DESIGN REVIEW COMMITTEE

December 4, 2014
5:30 p.m.
2nd Floor Council Chambers
1095 Duane Street • Astoria OR 97103

STAFF REPORT AND FINDINGS OF FACT

SUBJECT: DESIGN REVIEW REQUEST (DR14-06) BY DONNA AND TRACY BLACK TO CONSTRUCT A COMMERCIAL BUILDING AT 1619 MARINE DRIVE

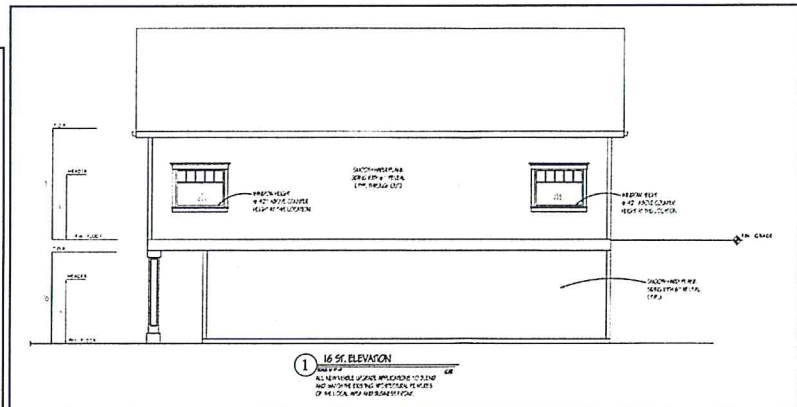
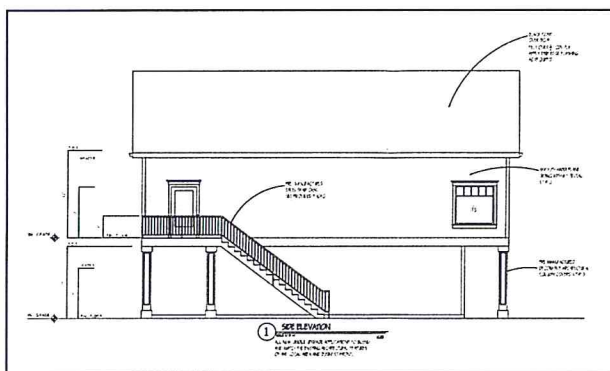
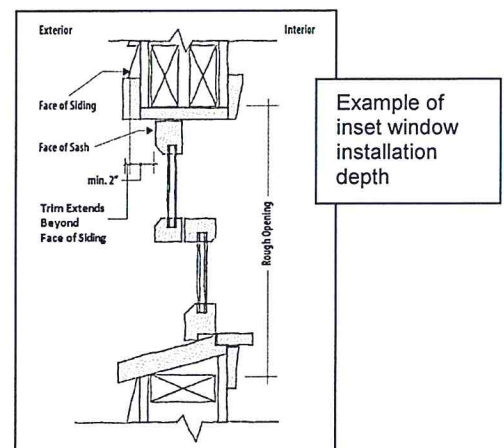
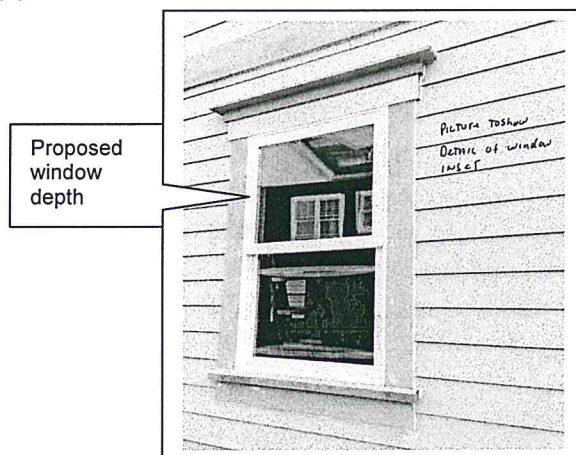
Finding: All windows are vinyl clad wood and are fixed storefront windows with simulated multi-lites above. The windows are mostly single, square with some more horizontal windows due to the interior configuration. All lites will need to be true divided or have external muntins (Condition 1). There are no blank walls.

The windows should be installed inset similar to a historic depth so that the windows do not protrude beyond the plane of the facade as indicated in the graphic (Condition 2). The applicant has shown the window inset similar to a window in the Gateway Overlay Area. However, the depth should be as per the example below which appears to be more than the picture provided by the applicant.

1. Any windows with grids shall be true divided or shall have external grids.
2. Windows and casings shall be installed so that the windows do not protrude beyond the plane of the facade, and so that the casing protrudes beyond the siding.
3. Fiber cement siding shall be smooth, not textured.
4. The applicant shall submit a sign permit for review and approval of the Planner for the design and location of any proposed signage to comply with the requirements of the Gateway Overlay Zone.
5. Exterior light fixtures shall have diffused lighting.
6. Windows shall be clear and not tinted or reflective except as required by Building Codes.
7. Any change in design or material shall be submitted to the Community Development Department for review and approval.

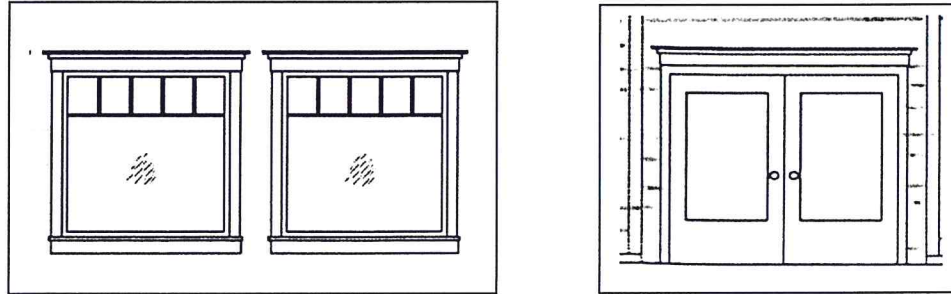
Window and door exterior casings proposed to be 5.5" x 3/4" or larger with crown and lower sill and shall protrude beyond the plane of the siding. Doors would be single lite fiberglass or metal.
